## ENVIRONMENTAL COMMISSION MOTION 20221102-002

**Subject:** Brodie Oaks Redevelopment PUD, C814-2021-0099

# **Brodie Oaks Redevelopment PUD**

**C814-2021-0099**

# Exhibit G: Grading Plan

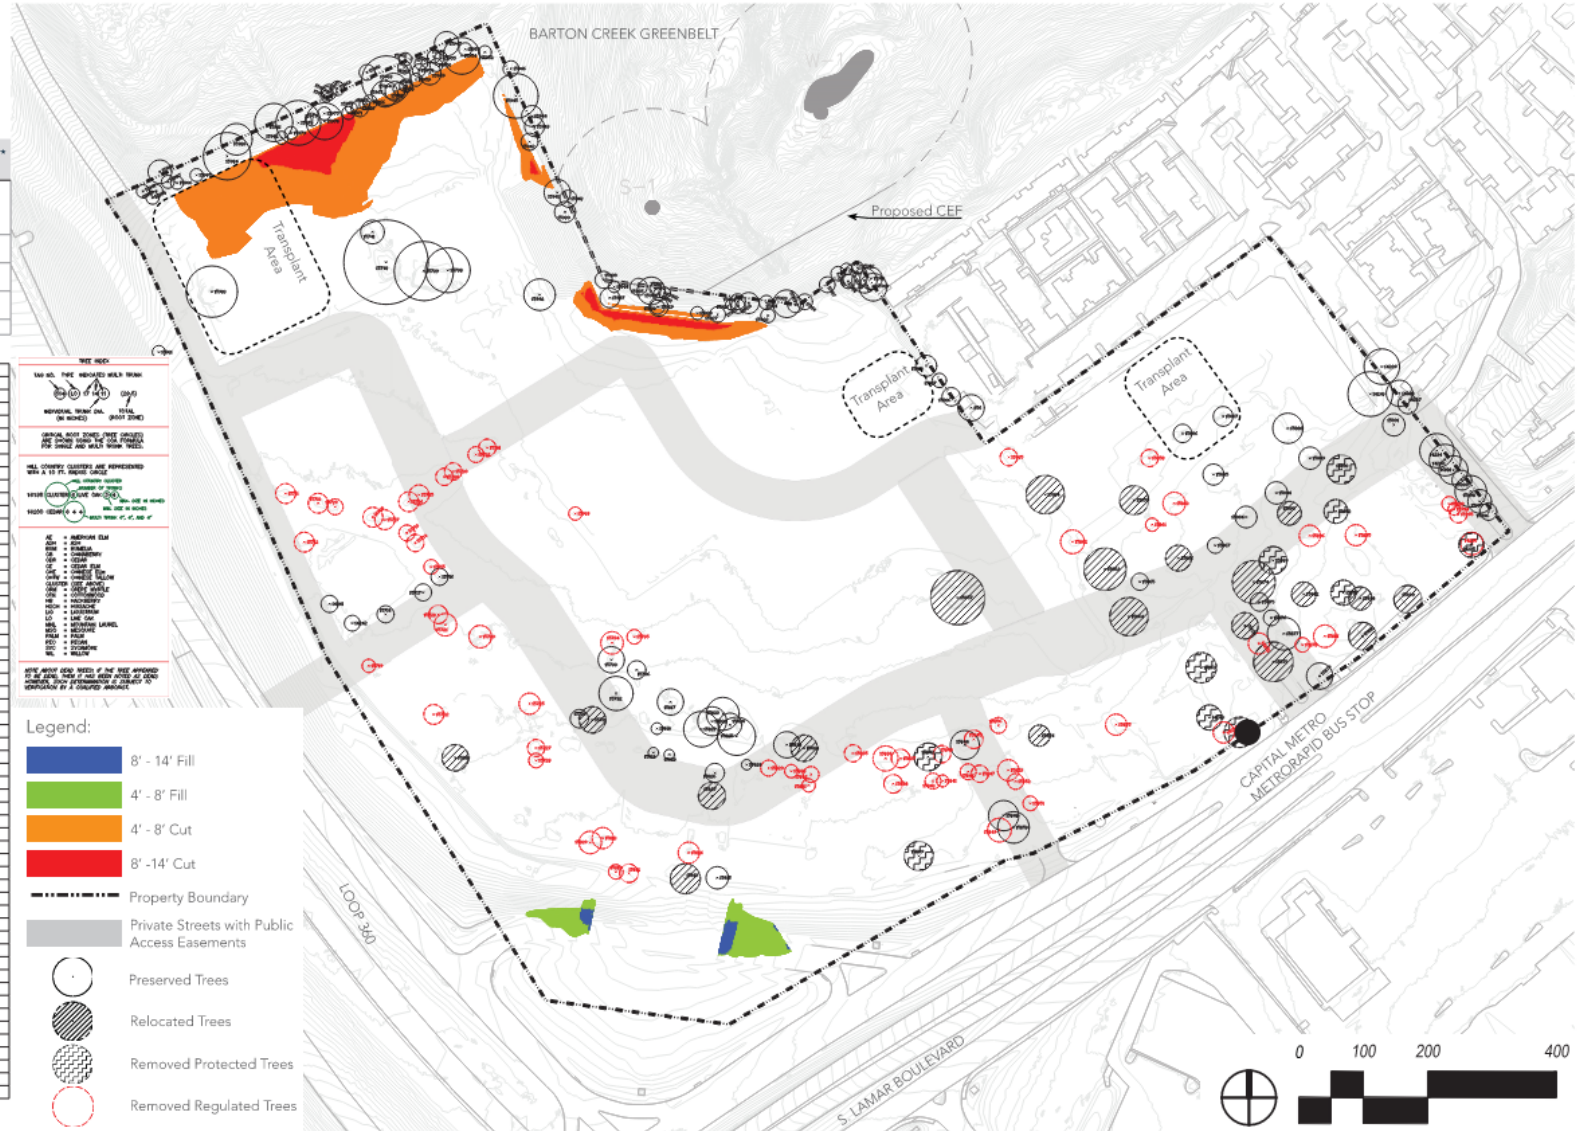
- **25-8-341 (Cut Requirements)** shall be modified to allow cut not to exceed a maximum of fourteen (14) feet as indicated on Exhibit G.
- **25-8-342 (Fill Requirements)** shall be modified to allow fill not to exceed a maximum of fourteen (14) feet as indicated on Exhibit G.
- **25-8-281 (Critical Environmental Features)** shall be modified to allow encroachment into CEFs as indicated on Exhibit F.
- **SOS Ordinance Section A of 25-8-514 (Pollution Prevention Required)** shall be modified to allow a maximum impervious cover for the site of 56% net site area.

# Exhibit F: Environment

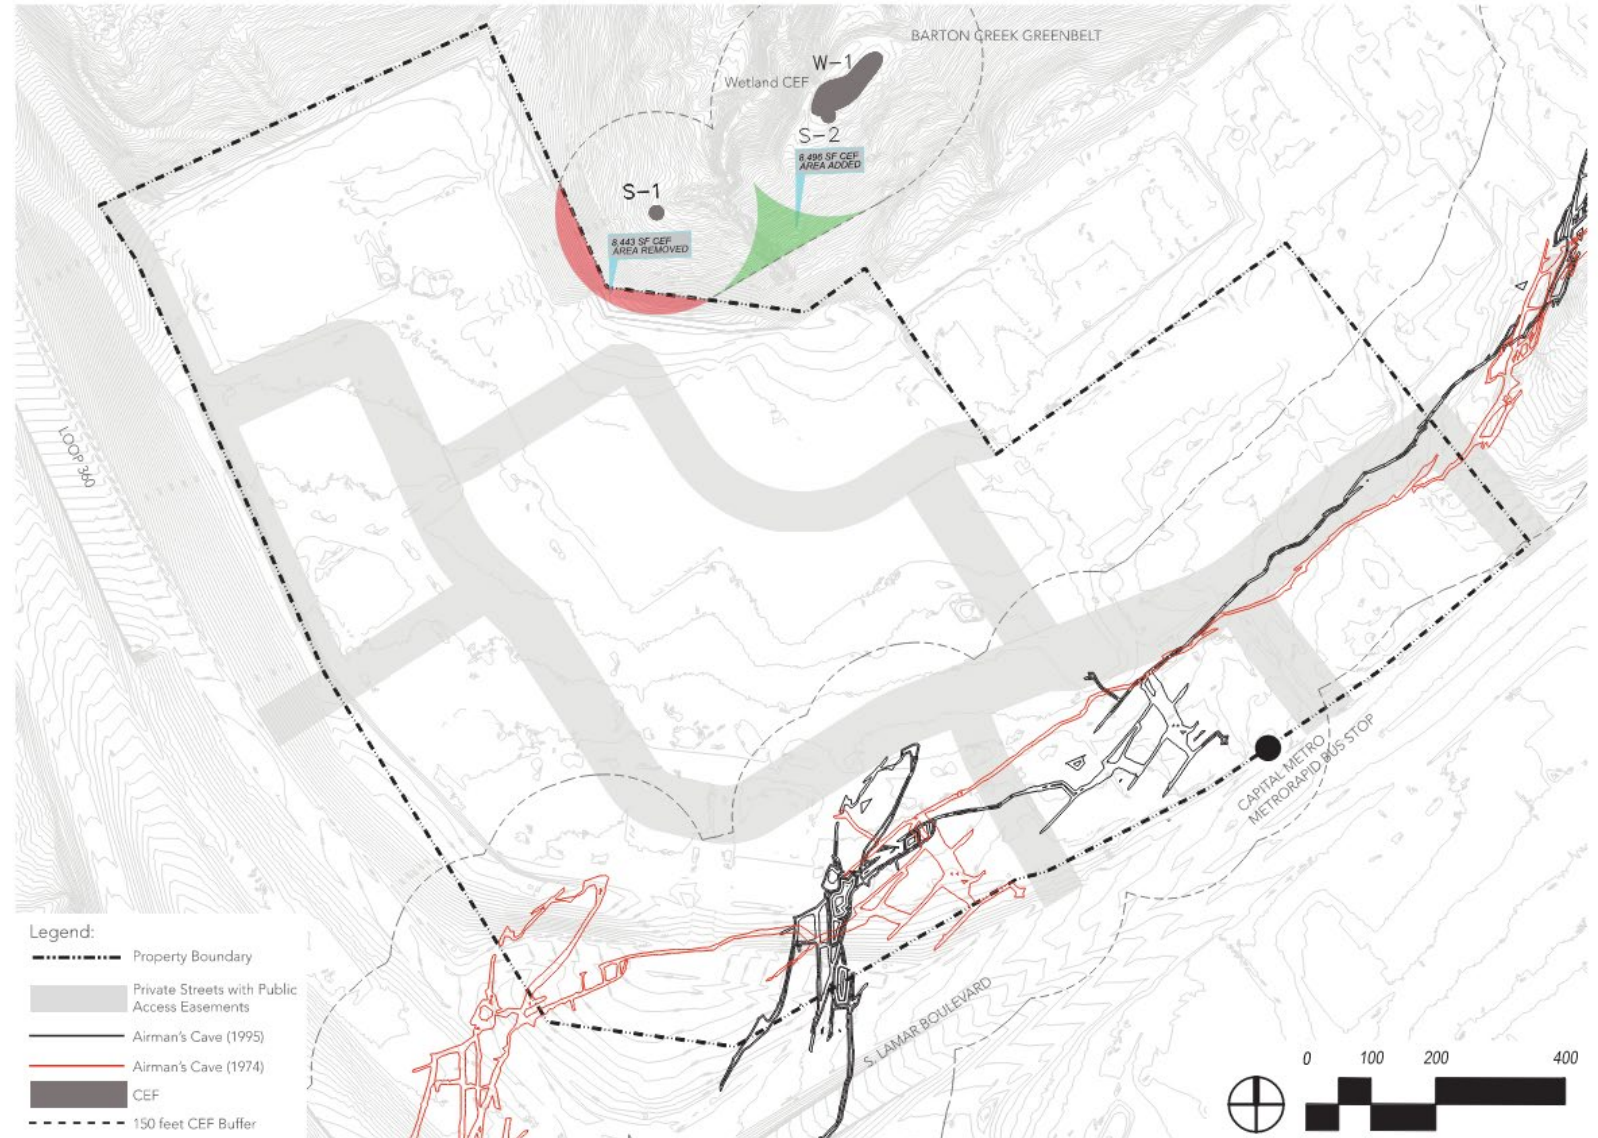
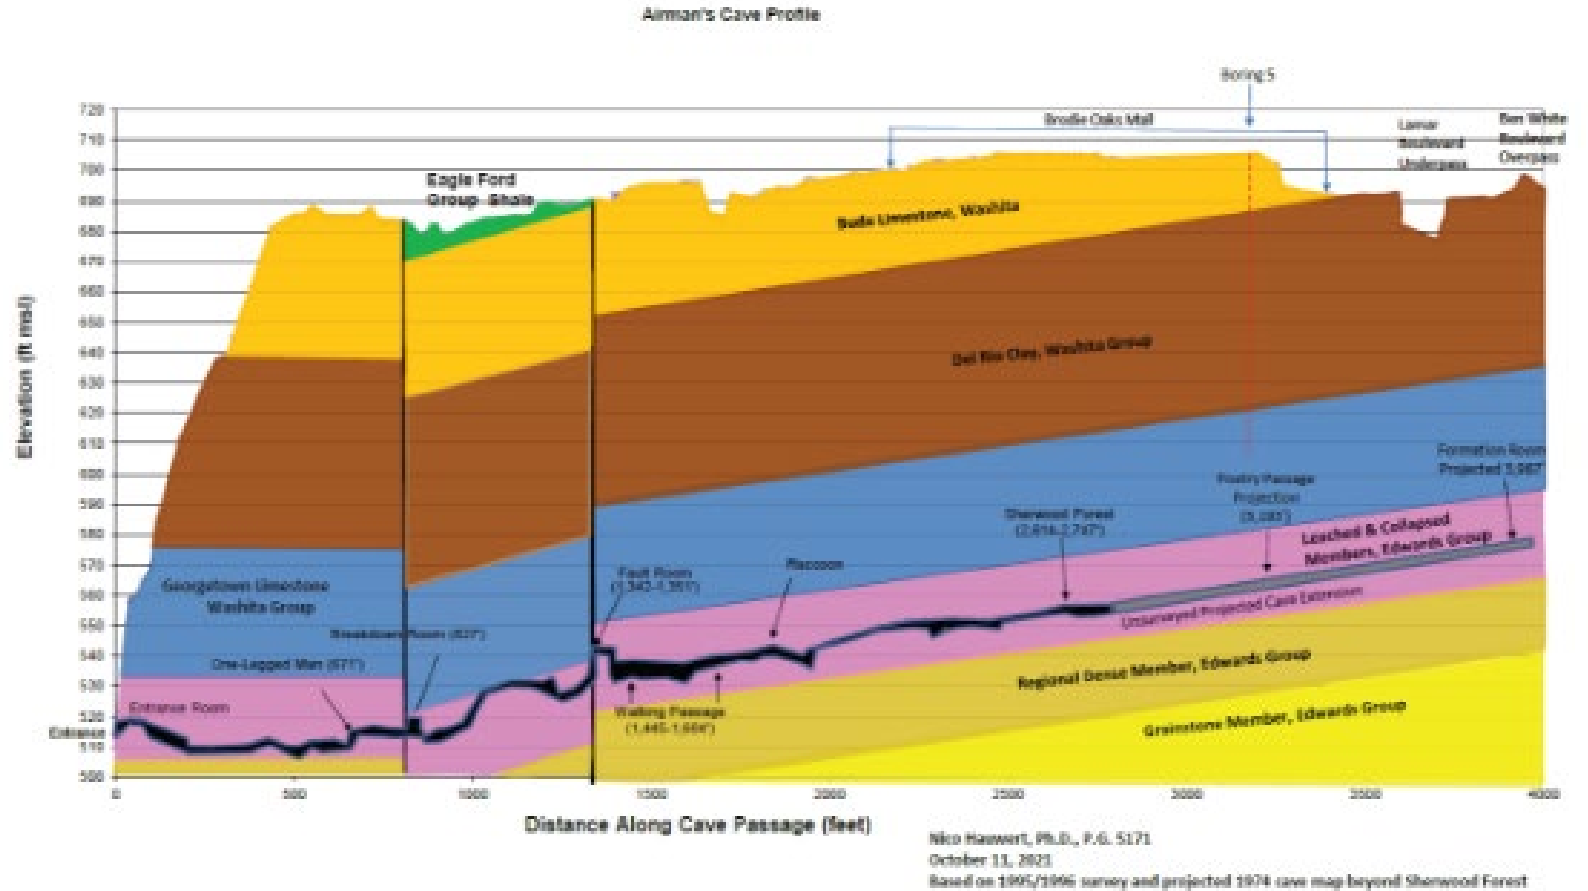
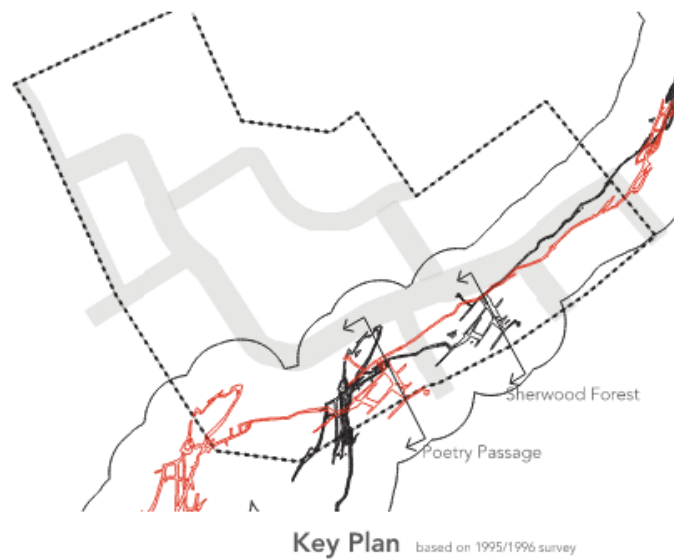
- c. 25-8-342 shall be modified to allow fill not to exceed a maximum of fourteen (14) feet.
  - d. 25-8-281 shall be modified to allow encroachment into CEFs as indicated on Exhibit F.

1. Modify CEF setback for S-1/S-2
2. Impact to Airman's Cave CEF setback is limited of up to 80' with conditions
3. Protective fencing for CEFs
